SUBJECT: ISSUANCE OF AMENDMENT NO. 168 TO FACILITY OPERATING LICENSE  
NO. DPR-62 - BRUNSWICK STEAM ELECTRIC PLANT, UNIT 2, REGARDING  
MAXIMUM EXPANDED OF OPERATING DOMAIN (TAC NO. 72853)

BRUNSWICK STEAM ELECTRIC PLANT, UNIT 2

Amendment No. 168  
License No. DPR-62

ATTACHMENT TO LICENSE AMENDMENT NO. 168

Figure 2.2.1-1. APRM Flow Bias Scram Relationship to Normal Operating Conditions

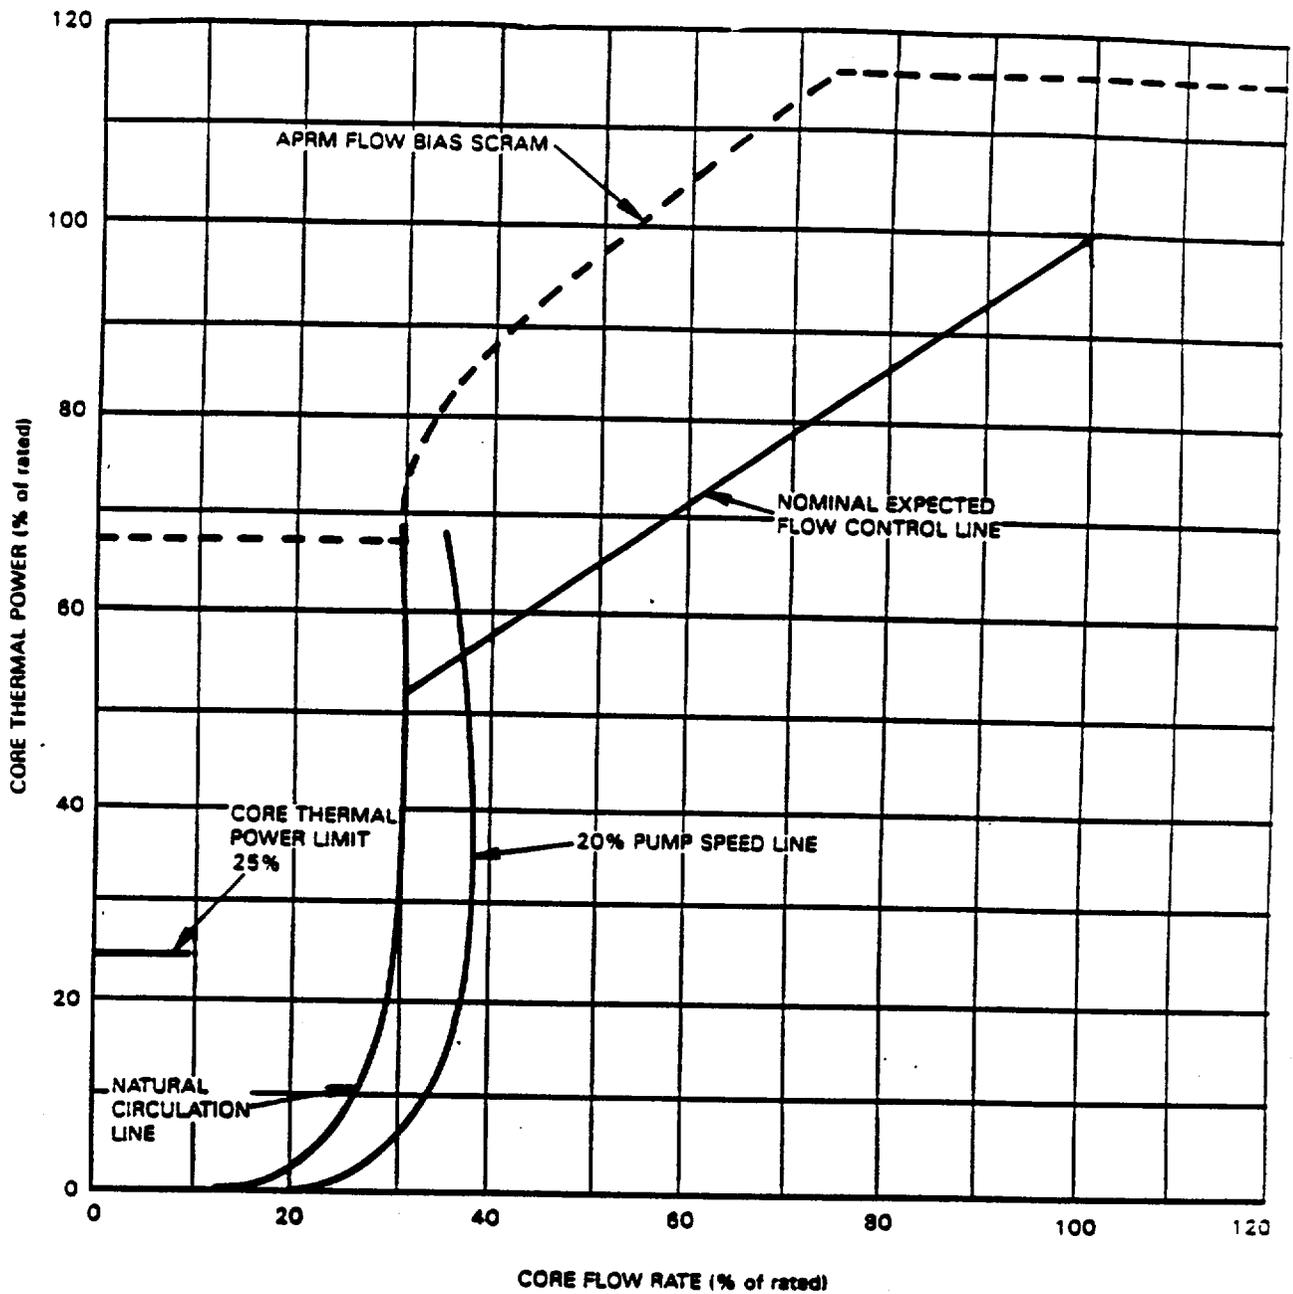
The MEOD proposal changes the APRM flux scram lines on the power/flow map and permits operation up to the new APRM flux scram line ( $0.66W + 64$  percent) and up to the intersection with the 100 percent power line occurring at a flow of 75 percent. This is a standard change for MELLL. For ICF, the proposed flow increase is to 105 percent core flow at 100 percent power with a linear expansion to 110 percent core flow at 70 percent power. The increased flow would be allowed throughout a plant cycle. The flow-biased rod block trip equation is changed to  $0.66W + 58$  percent with a maximum value of 108 percent. The maximum value of 108 percent necessitates a modification to establish a clamping function for the rod block trip level (see Section 2.5).
